Fort Knox

**Fort Knox Mine
Plan of Operations Modification Request**

**Walter Creek Valley Heap Leach Facility Expansion
Barnes Creek Waste Rock Dump Expansion**

February 4, 2014

PROJECT: FORT KNOX PROJECT				
WALTER CREEK VALLEY FILL HEAP LEACH FACILITY S3 AND S4 - 2012				
TITLE: ON-HEAP SOLUTION CONVEYANCE/DISPERSION PIPES PLAN				
DESIGNED BY: JTR	LOCATION: DV101	PROJECT NUMBER: 00089.46	DRAWING NUMBER: 510	REVISION: 1
DRAWN BY: CB

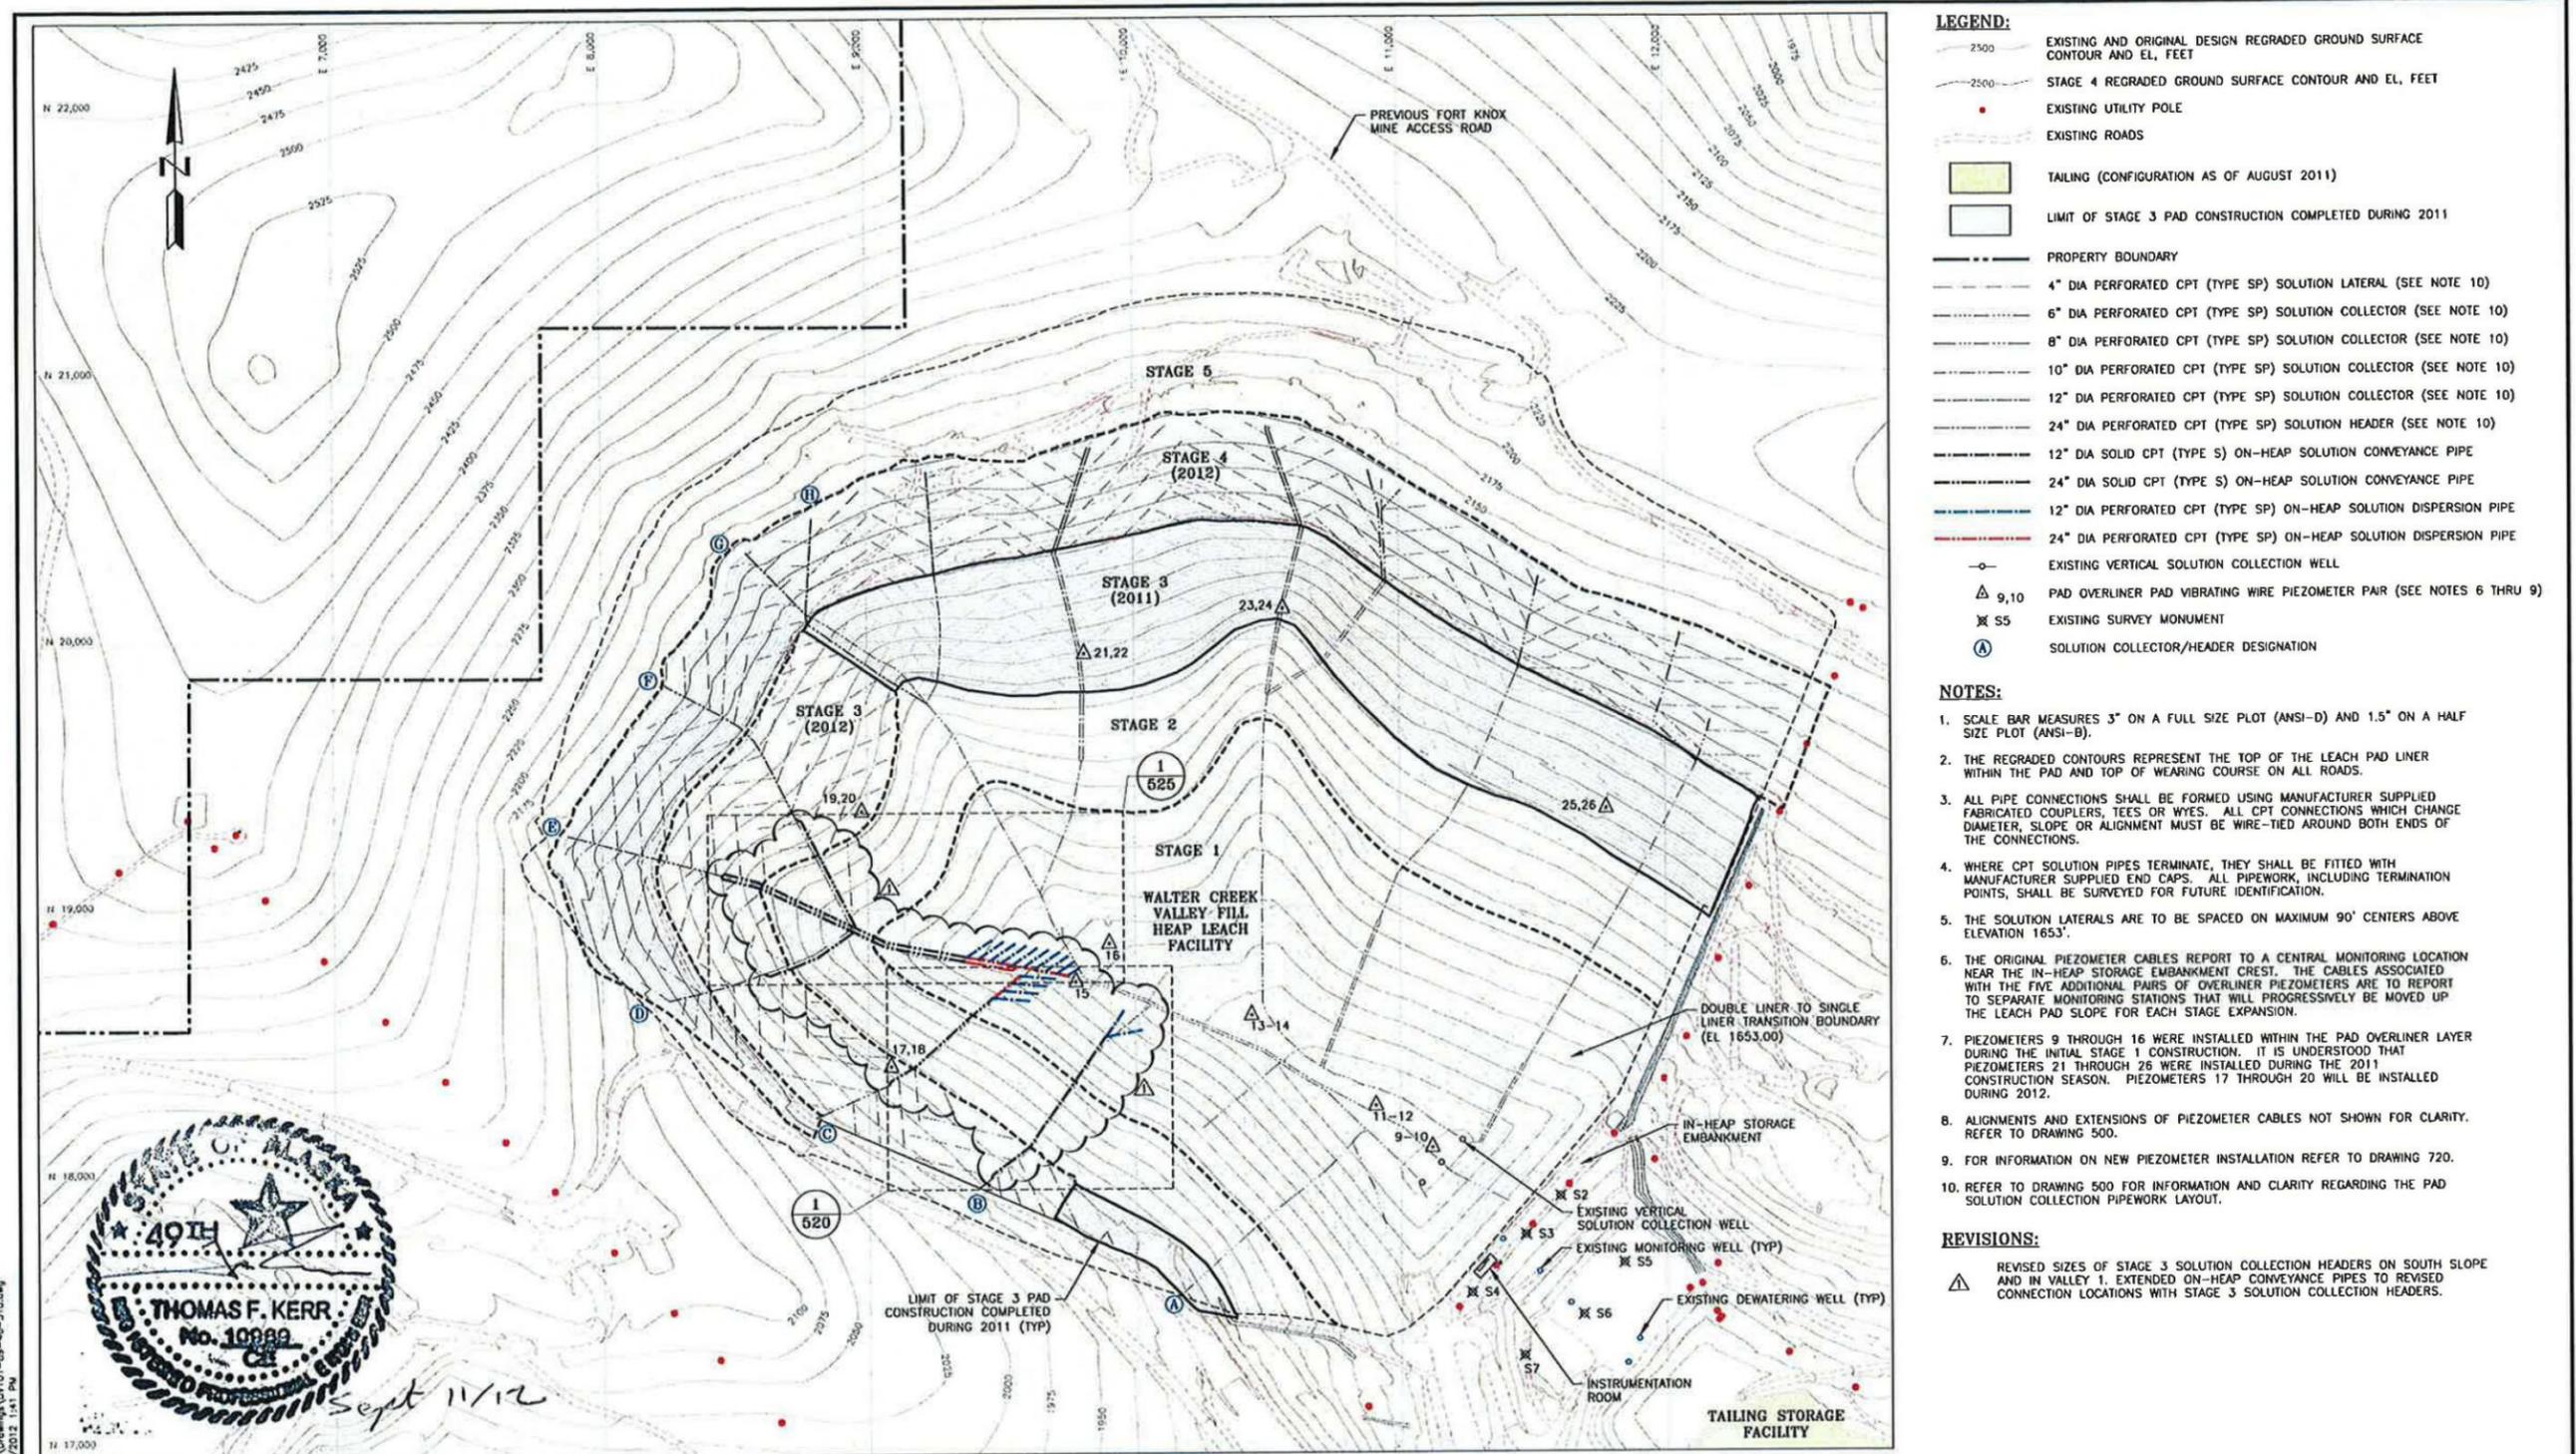
- REVISIONS:**
- REVISED SIZES OF STAGE 3 SOLUTION COLLECTION HEADERS ON SOUTH SLOPE AND IN VALLEY 1. EXTENDED ON-HEAP CONVEYANCE PIPES TO REVISED CONNECTION LOCATIONS WITH STAGE 3 SOLUTION COLLECTION HEADERS.

PROJECT: FORT KNOX PROJECT		WALTER CREEK VALLEY FILL HEAP LEACH FACILITY S3 AND S4 - 2012	
TITLE: ON-HEAP SOLUTION CONVEYANCE/DISPERSION PIPES NETWORK - SHEET 2 OF 2			
DESIGNED BY: JTR	LOCATION: DV101	PROJECT NUMBER: 00089.46	DRAWING NUMBER: 525
DRAWN BY: CB			REVISION: 1

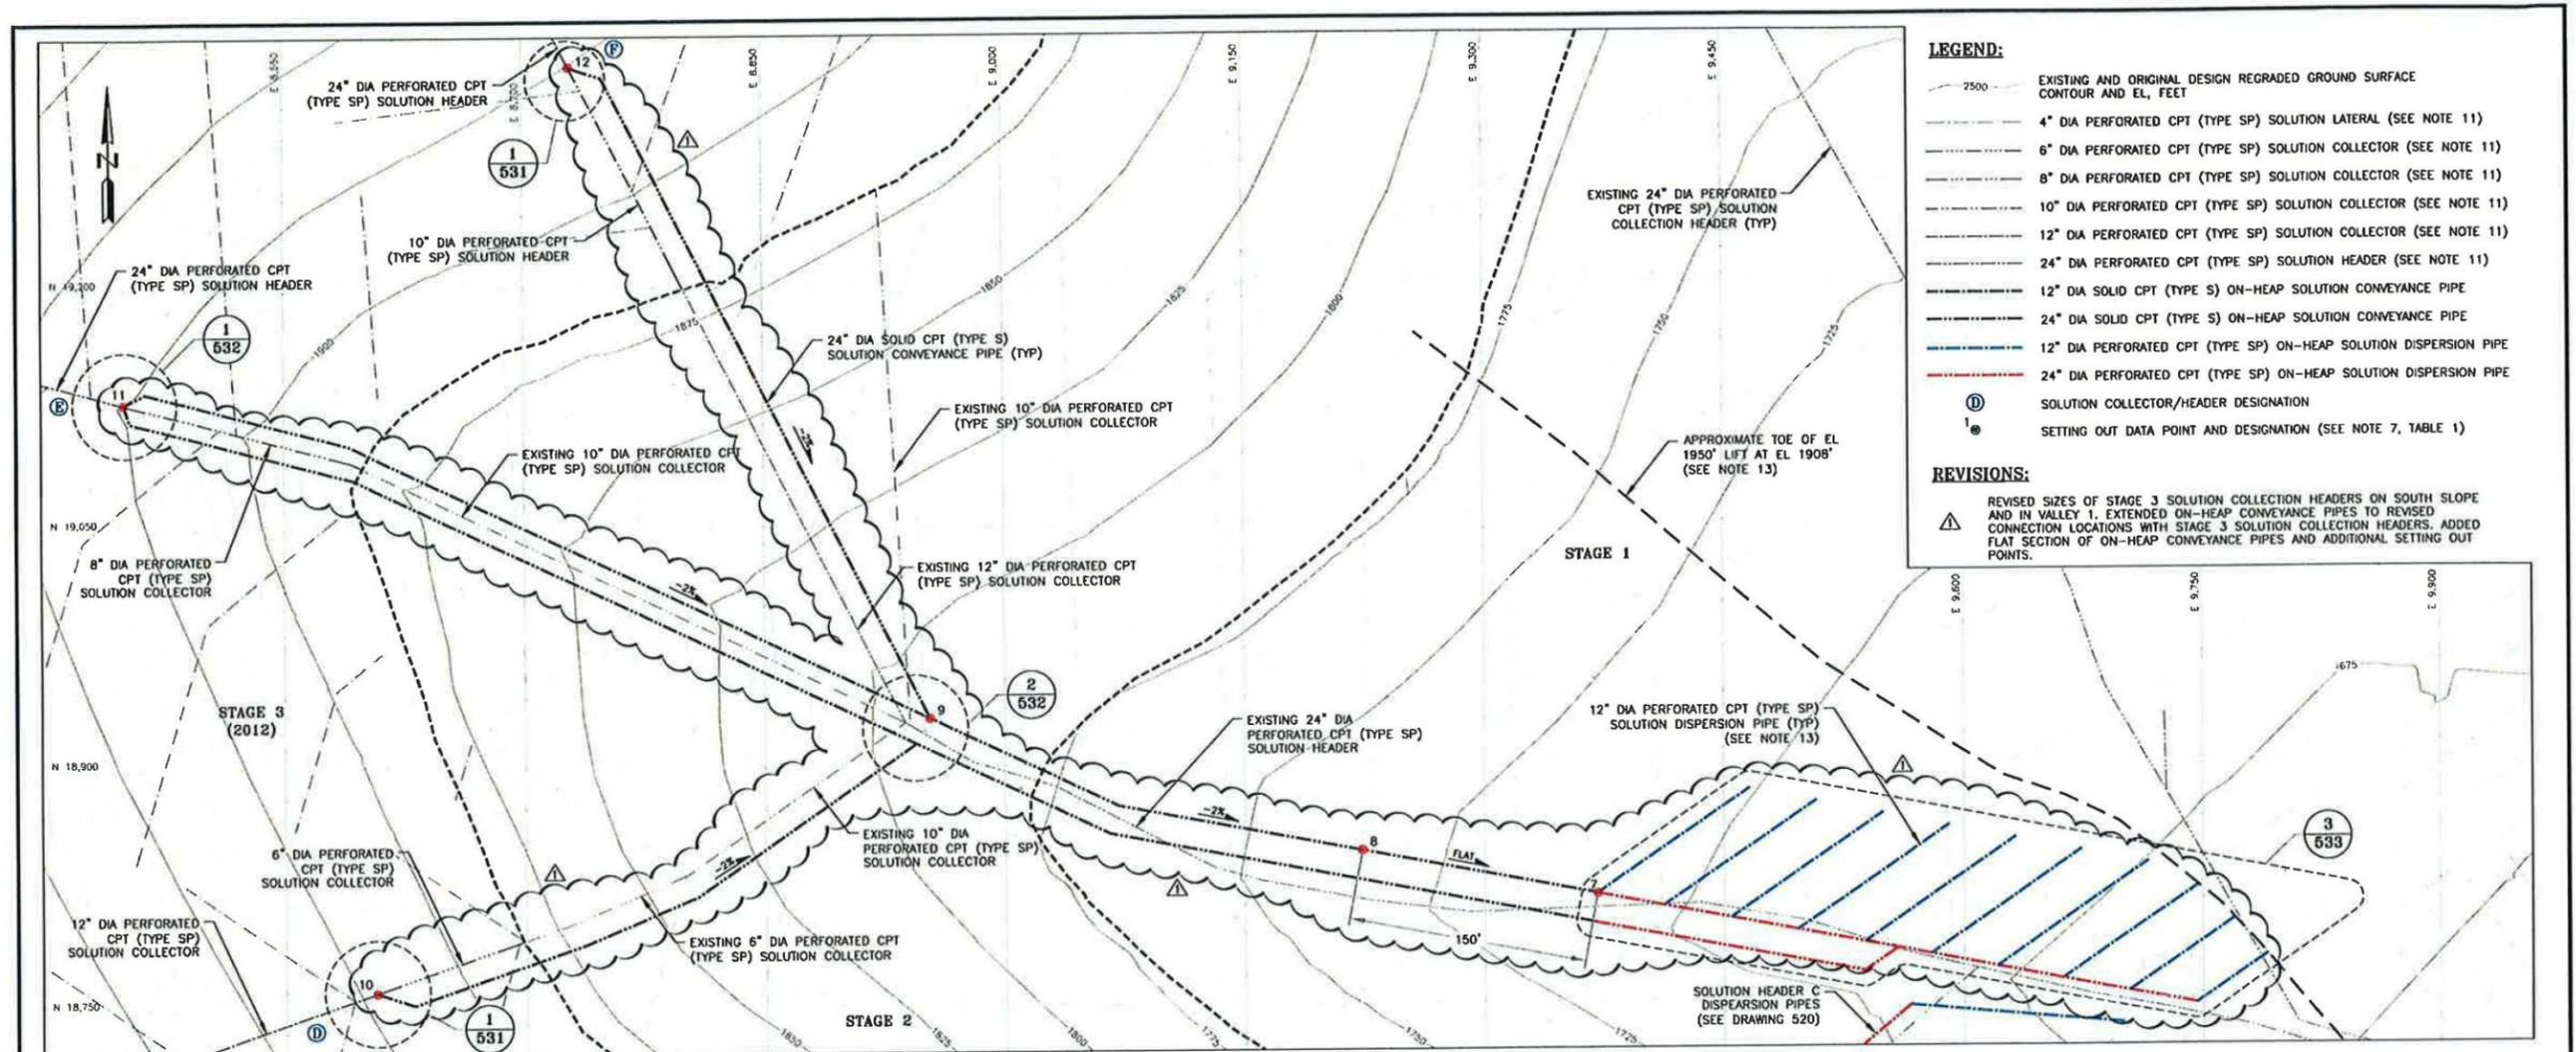
- Design modifications were made to the on-heap conveyance and dispersion pipes by raising the connections to the on-heap solution conveyance and dispersion pipework based on the existing conditions of the loaded heap [*Knight Piesold, WCHLF Approved Design – Construction Addendum No. 14: Reissue for Construction Drawings (Revision 3) and On-Heap Pipework concept 2012 Construction, Remaining Stage 3 and 4, October 18, 2012*]. The design modifications are illustrated by Attachments 2 – 4, WCHLF On-Heap Solution Conveyance/Dispersion Pipes Plan, WCHLF On-Heap Solution Conveyance/Dispersion Pipes Network Sheet 1 of 2, and WCHLF On-Heap Solution Conveyance/Dispersion Pipes Network Sheet 2 of 2, respectively. The design modifications include:

- Installation of the perforated dispersion pipe networks at elevation 1908 feet (ft).
 - Incorporation of a flat section of solid on-heap conveyance pipe, connecting to the perforated dispersion pipe networks at elevation 1908 ft.

- The remaining sections of the solid on-heap conveyance pipe installed at a 2-percent grade from the end of the flat section of solid conveyance pipe to the tie-in point with the pad surface.

- The pad solution collection headers upstream of the on-heap pipe connections will no longer be connected to the collection headers downstream on the pad surface and will only tie directly to the on-heap conveyance pipes. The downstream perforated solution collection headers will be extended up the pad slope past the on-heap connection and run adjacent to the perforated upstream pipe for a short distance (5 ft).

- △ REVISED SIZES OF STAGE 3 SOLUTION COLLECTION HEADERS ON SOUTH SLOPE AND IN VALLEY 1. EXTENDED ON-HEAP CONVEYANCE PIPES TO REVISED CONNECTION LOCATIONS WITH STAGE 3 SOLUTION COLLECTION HEADERS. ADDED FLAT SECTION OF ON-HEAP CONVEYANCE PIPES AND ADDITIONAL SETTING OUT POINTS.
